FINAL PLAT

CEDAR VIEW SECOND ADDITION

RE: SUB 2000-79 -- One-Step Final Plat of CEDAR VIEW SECOND ADDITION

STAFF REPORT
(One-Step Final Plat Approved 9/28/00)

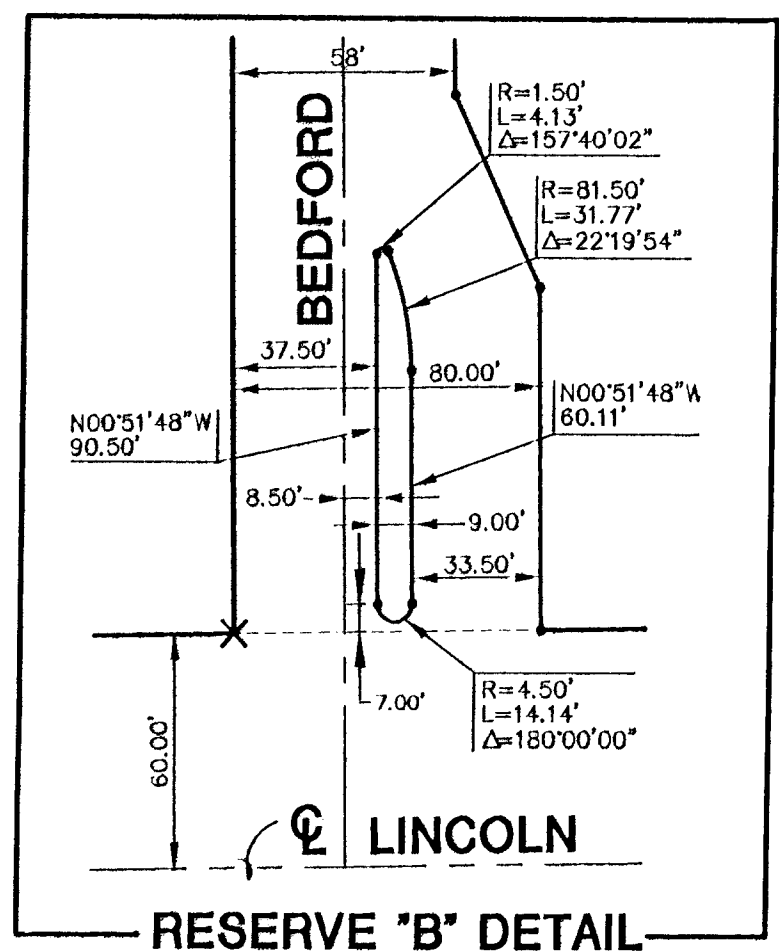
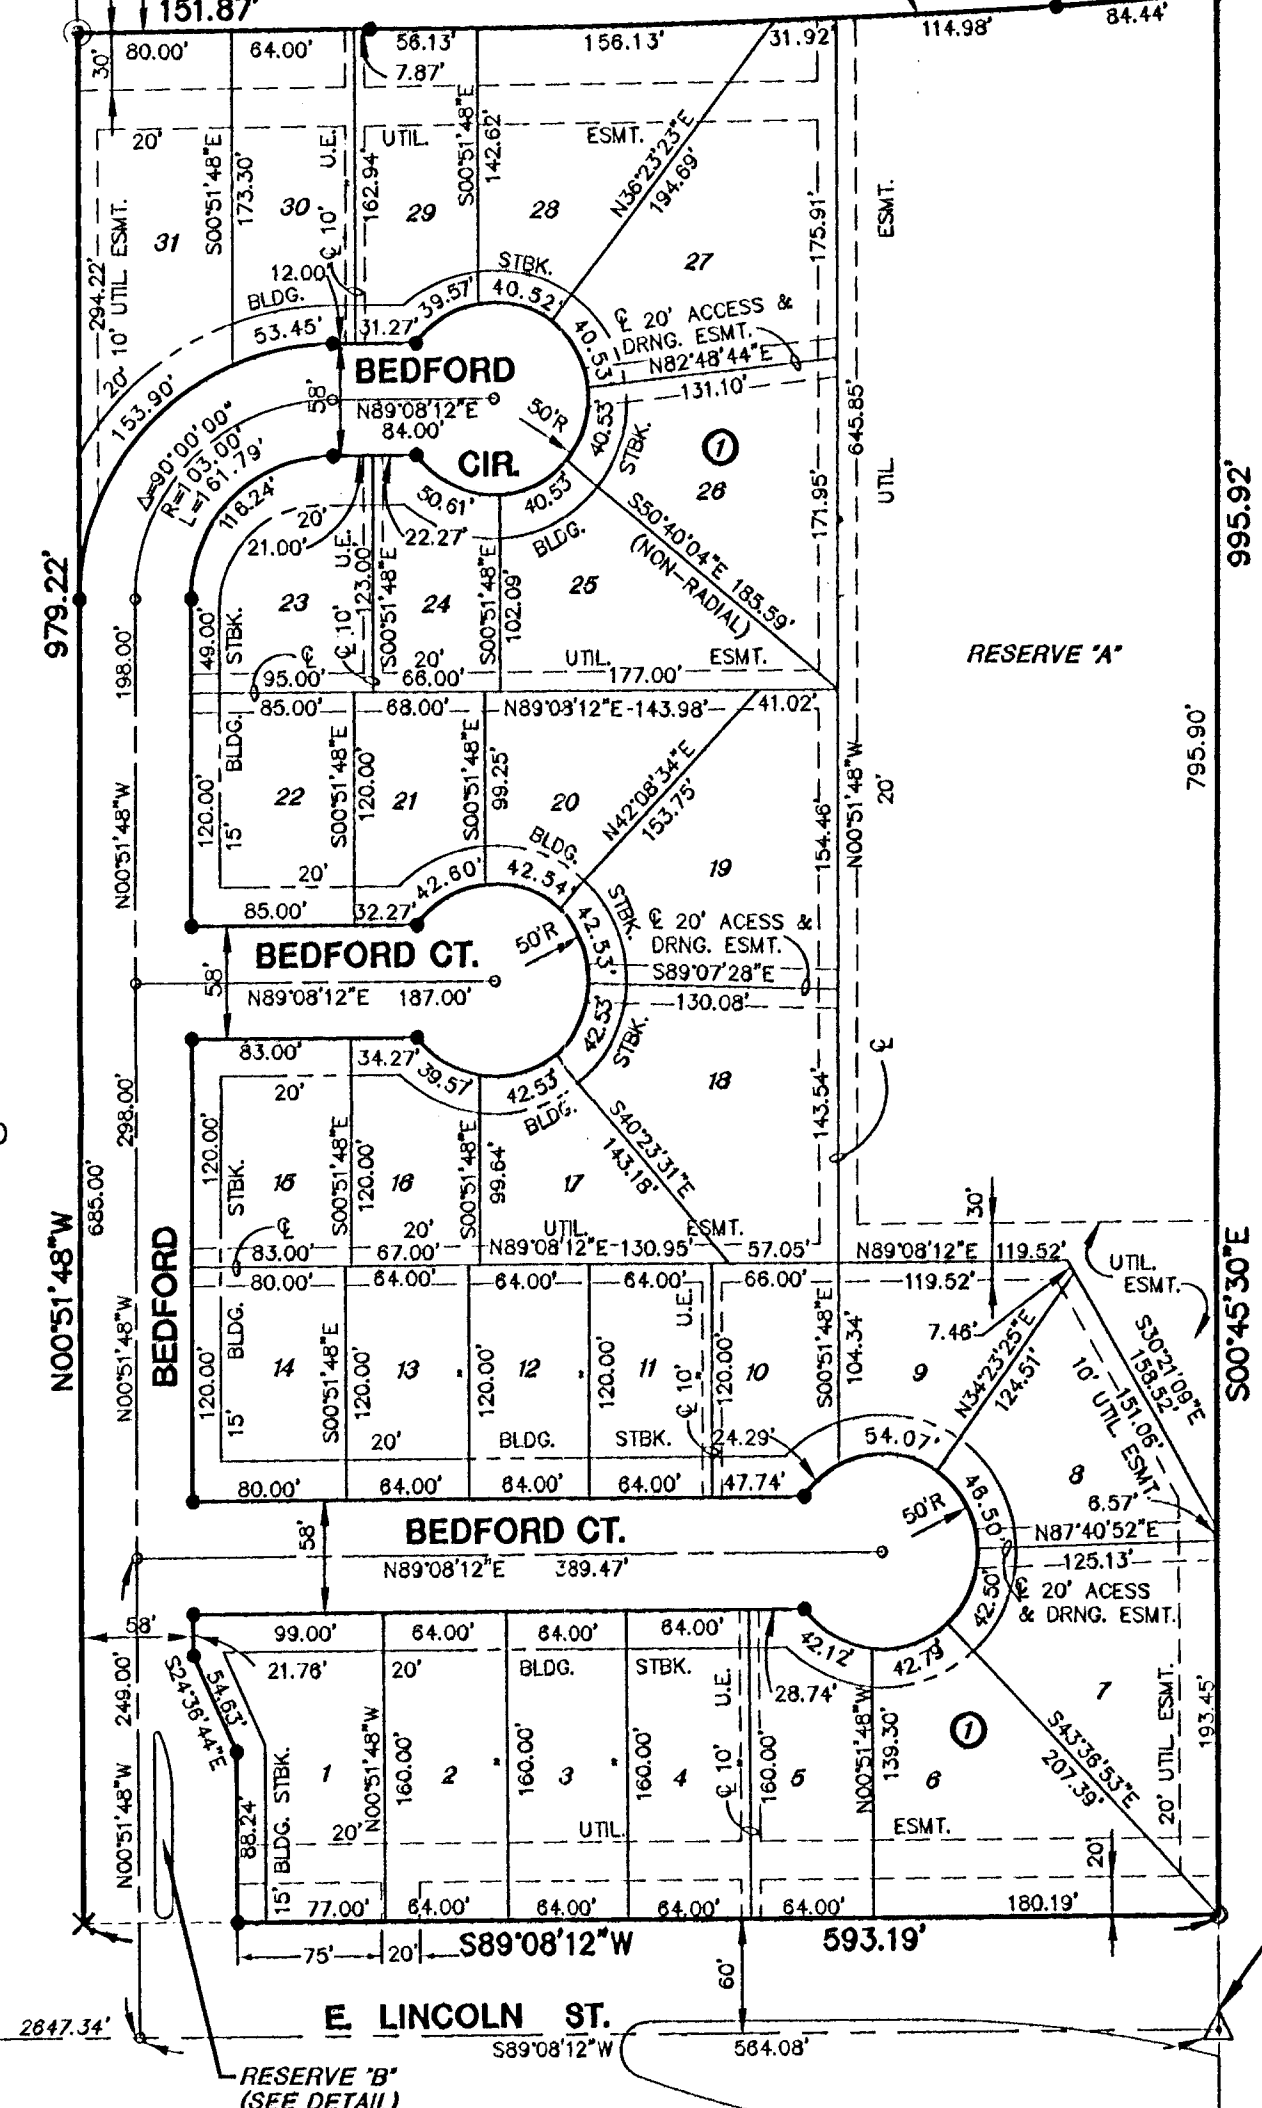
- E. City Engineering needs to comment on the status of the applicant's drainage plan. A drainage plan is needed. A minimum pad elevation needs to be platted adjacent to Reserve A.

- F. The right-of-way of the Kansas Turnpike and Condemnation Case number should be denoted.
- G. The applicant shall dedicate complete access control along the Kansas Turnpike.

- H. A minimum pad elevation should be denoted as was platted in the Cedar View Addition unless this requirement has been revised.
- I. Provisions shall be made for ownership and maintenance of the proposed reserves. The applicant shall either form a lot owners' association prior to recording the plat or shall submit a

- L. The use of Reserve A for utilities located within the platted easements should be referenced in the plattor's text.
- M. The legal description should delete reference to the southwest quarter.

- N. The corner tie point should reference the "SW corner of the NW quarter".
- O. The section center should be located on the final plat tracing.
- P. A legend should be included on the final plat tracing.

- Q. City Fire Department shall comment on the acceptability of the plat's street names. **The northernmost cul-de-sac needs to be revised to Bedford Circle.**

- R. For Lots 1-5 and 29-31, the lots exceed the maximum lot width to lot depth ratio of 2.5 to 1. A modification will need to be approved. **A modification has been approved.**

- S. City Fire Department needs to comment on the length of Bedford which exceeds the 600-ft maximum length for cul-de-sac streets. **The length of the street is acceptable.**

- CC. The representatives from the utility companies should be prepared to comment on the need for any additional utility easements to be platted on this property. **KGE has requested additional easements.**
